Well Name: CANAL 20/19 FED COM	Well Location: T21S / R27E / SEC 20 / NENE / 32.4702101 / -104.2047139	County or Parish/State: EDDY / NM
Well Number: 853H	Type of Well: CONVENTIONAL GAS WELL	Allottee or Tribe Name:
Lease Number: NMNM0354232	Unit or CA Name:	Unit or CA Number:
US Well Number: 3001557072	Operator: MEWBOURNE OIL COMPANY

Notice of Intent

Sundry ID: 2866989

**Procedure Description:** Mewbourne Oil Company requests that the following change be made to the Canal 20/19 Fed Com #853H (API 30-015-57072): • Change SHL f/ 940 FNL & 355 FEL (20) to 200 FNL & 305 FEL (20) • Change BHL f/ 1810 FNL & 100 FWL (19) to 490 FNL & 100 FWL (19) • Attached C102, Dir Plan & Plot, Drlg Program reflecting requested changes.

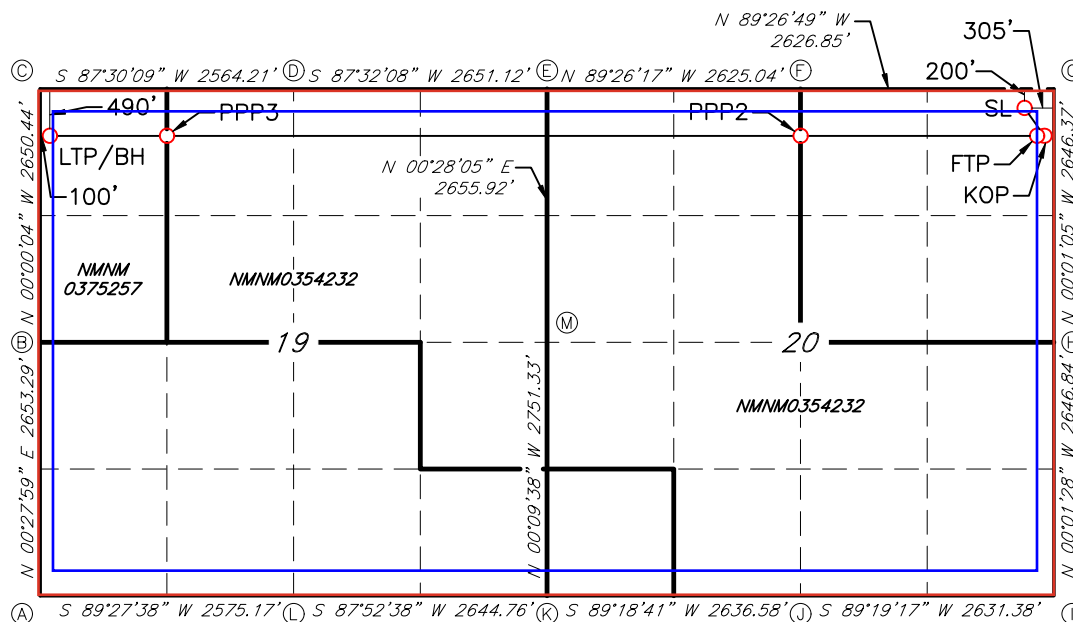
Mewbourne Oil Company requests that the following change be made to the Canal 20/19 Fed Com #853H (API 30-015-57072):

- Change SHL f/ 940 FNL & 355 FEL (20) to 200 FNL & 305 FEL (20)
- Change BHL f/ 1810 FNL & 100 FWL (19) to 490 FNL & 100 FWL (19)
- Attached C102, Dir Plan & Plot, Drlg Program reflecting requested changes.

MEWBOURNE OIL COMPANY  
CANAL 20/19 FED COM #853H  
(200' FNL & 305' FEL)  
SECTION 20, T21S, R27E  
N. M. P. M., EDDY CO., NEW MEXICO

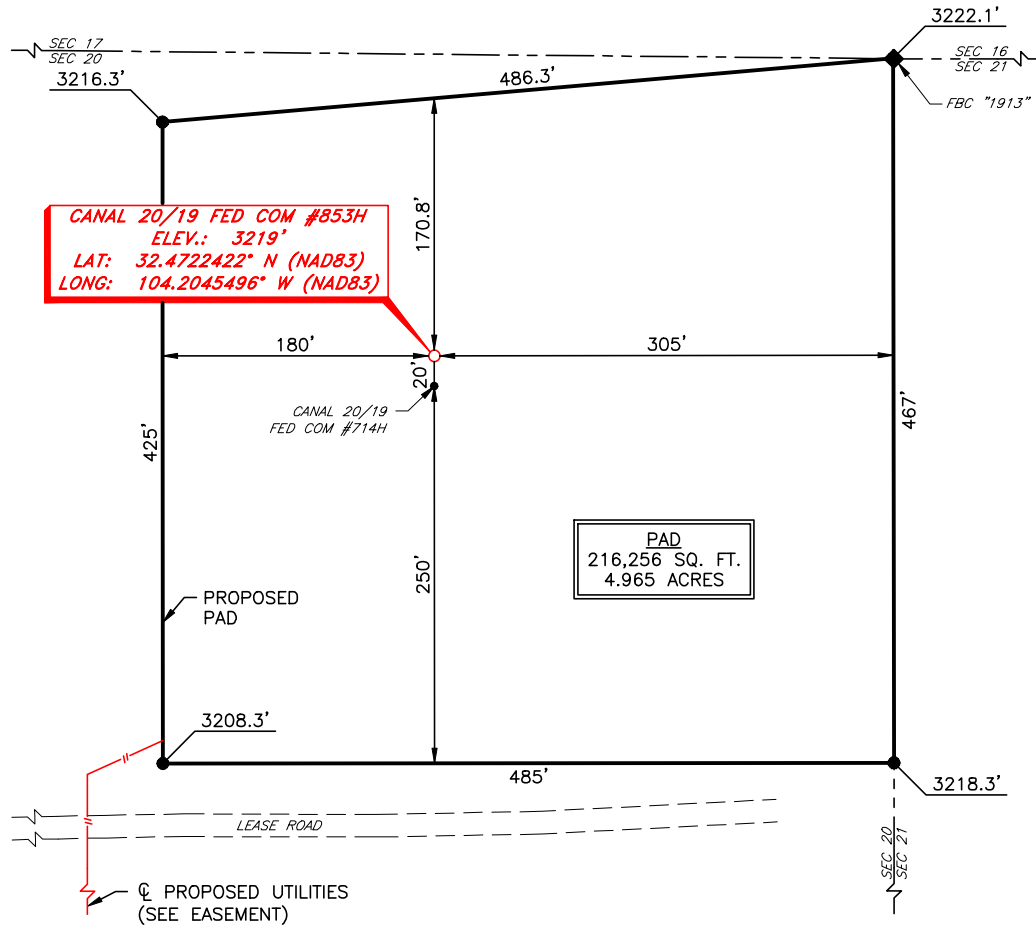
2	NAME CHANGE	08/05/25
1	RESTAKE	07/15/25
NO.	REVISION	DATE
JOB NO.: LS24020156D3		
DWG. NO.: 24020156D3-5
